F.4 1475 Fort Street: Development Permit with Variance Application No. 00120

The Council of the City of Victoria will consider issuing a Development Permit with Variances for the land known as 1475 Fort Street, in Development Permit Area 7B (HC), for purposes of constructing a four-storey residential building.

To:	Council	**Date:**	May 13, 2021
From:	Karen Hoese, Director, Sustainable Planning and Community Development		
Subject:	**Update on Development Permit with Variances Application No. 00120 for 1475 Fort Street**

1 PARKADE LEVEL
SCALE = 1 : 100

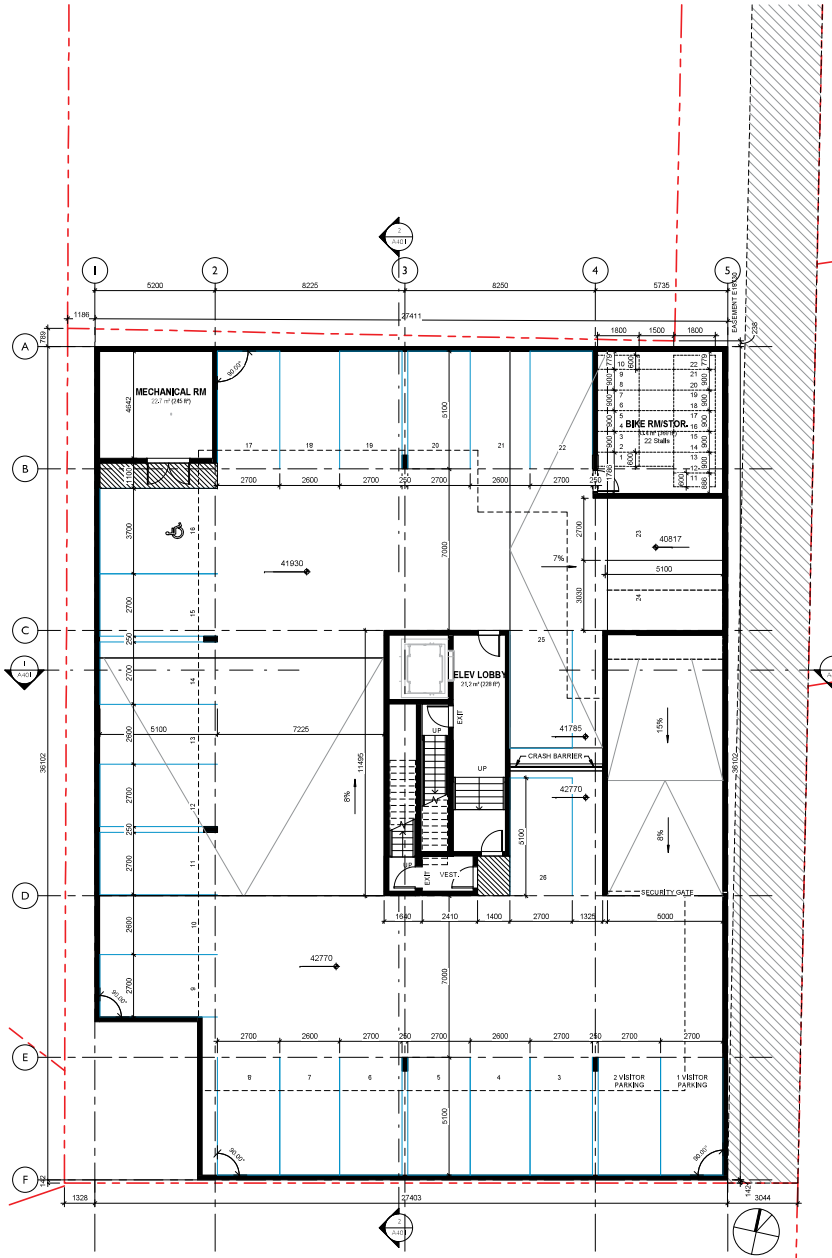
The applicant has reduced the footprint of the underground parking structure to provide a larger planting area with greater soil depth in the southwest corner of the property without increasing the parking variance associated with this proposal. Two columnar Hornbeam trees are proposed in this location as bylaw replacement trees. Adding new trees that can grow to full maturity by having access to greater soil depth helps to mitigate the impact of the site coverage, building height and setback variances by softening the visual appearance of the building and reducing privacy impacts by providing screening. They would also help to advance the City's Urban Forest objectives by providing ecological services such as wildlife habitat, storm water management and reducing urban heat island effects.

Sheet Name
949 PEMBERTON ROAD WINDOW OVERLAY

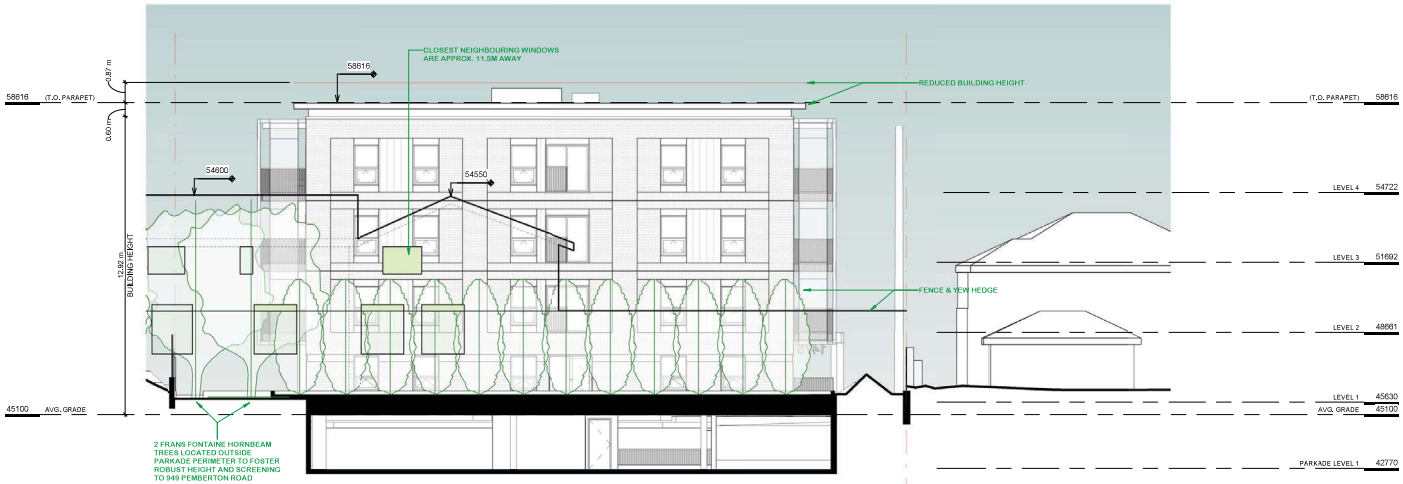
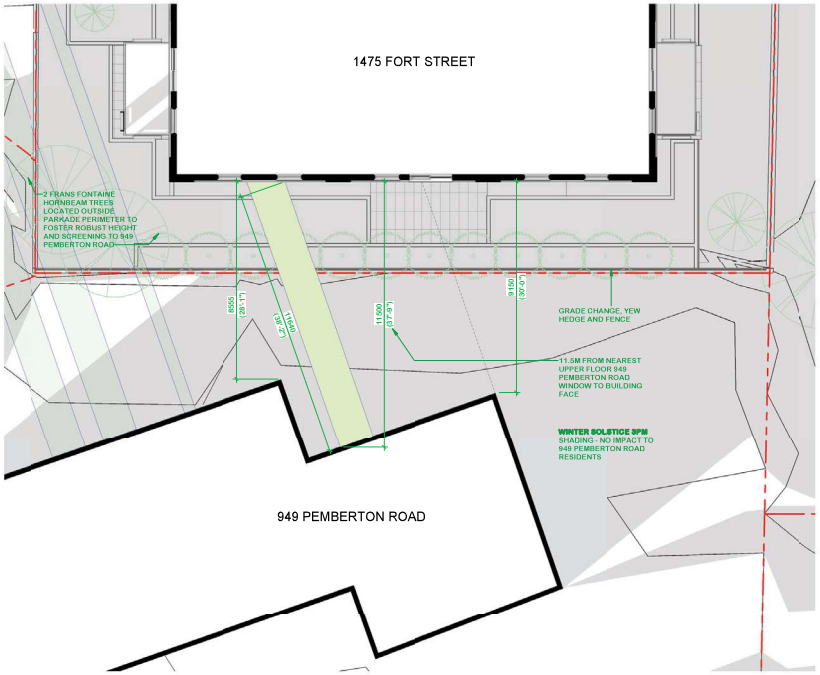
In addition to the plan revision, the applicant has provided a window overlay (sheet A502) to help illustrate the relationship between the northwest elevation of 949 Pemberton Road and the south elevation of the proposal. The window overlay demonstrates that there would be minimal privacy impacts as the buildings and windows are off-set from each other. The perimeter landscaping on both properties would also limit overlook into adjacent private outdoor space.

1475 Fort St. - Landscape Concept Plan

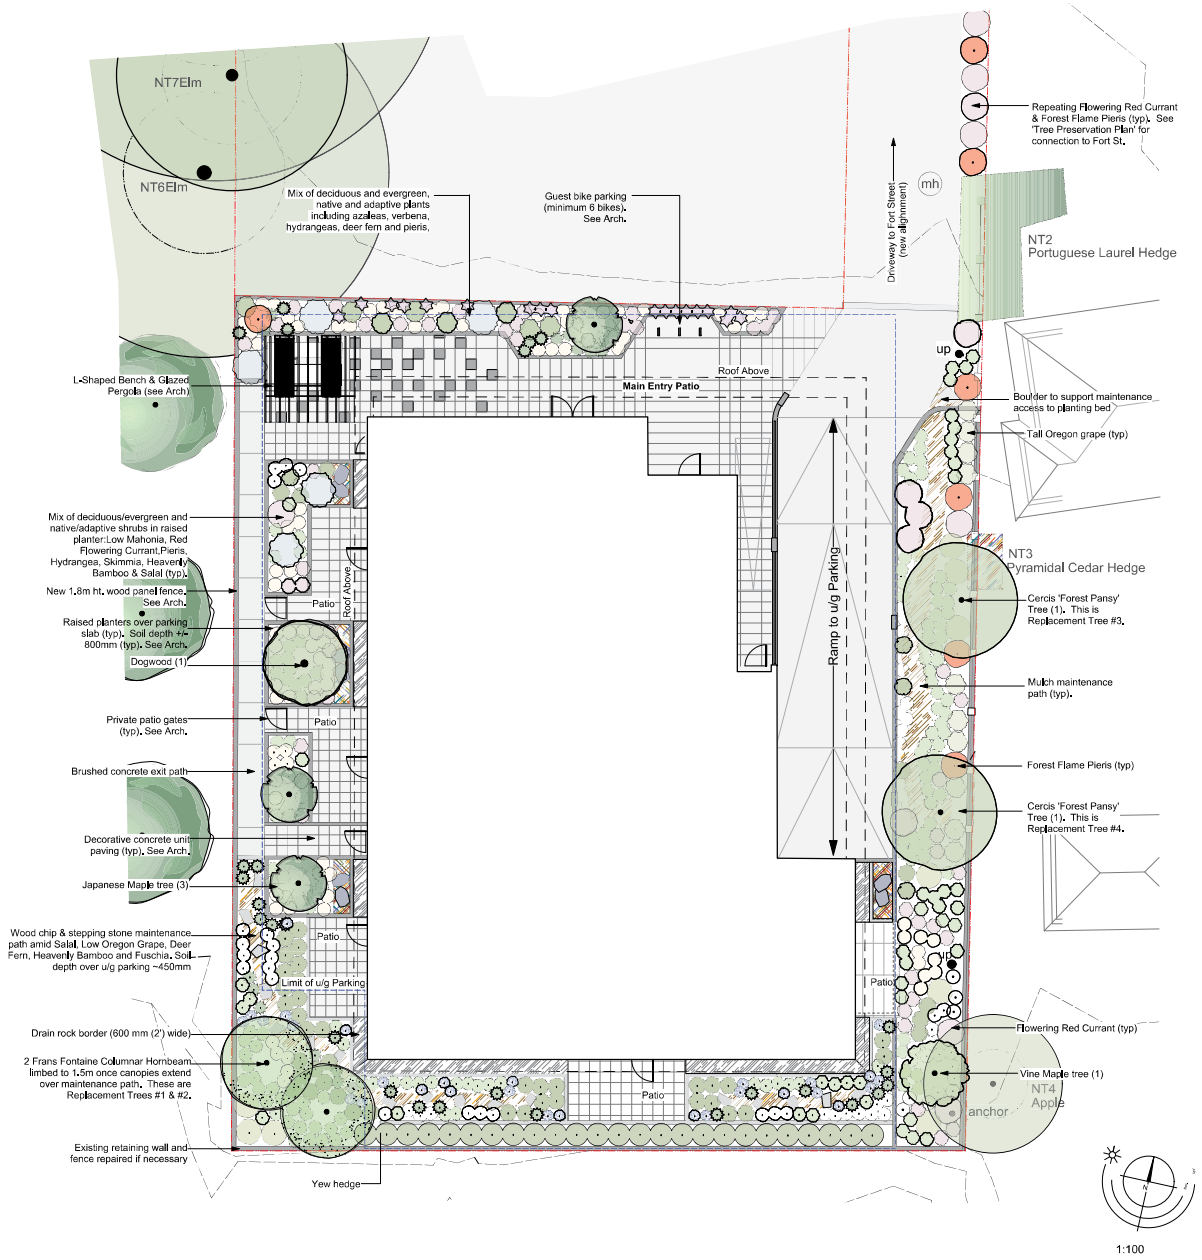
Lastly, the location of new trees on 1465 Fort Street are now shown on the Landscape Plan; however, these have been labelled incorrectly as replacement trees for the two bylaw protected trees that are proposed to be removed from the subject site. This is problematic because the *Tree Preservation Bylaw* requires replacement trees to be planted on the same property where the bylaw protected tree was removed; therefore, in order to comply with the bylaw, the plans will have to be amended to show four replacement trees on the subject site. Should Council choose to approve this Development Permit with Variance Application the appropriate language has been added to the recommended motion to deal with the Plan revision prior to issuing the permit.

Rev C 210208 Trees revised in response to adjusted u/g parking

1475 Fort St. - Tree Preservation Plan

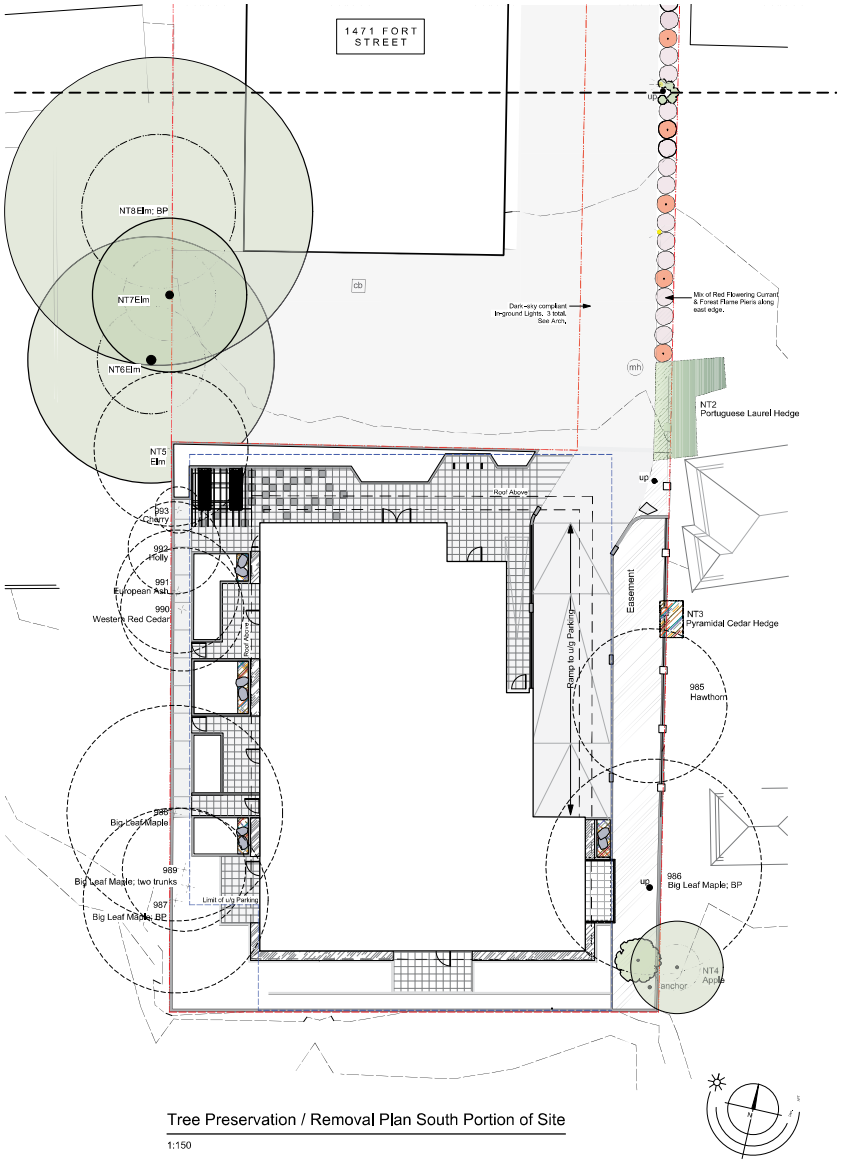
1) Two by-law protected trees, #986 and #987, are being removed (as per Arborist report). Four trees are required to replace the 2 by-law protected trees (2:1 replacement). they are identified on the Landscape Concept Plan.

Rev D 210208 Trees revised in response to adjusted u/g parking
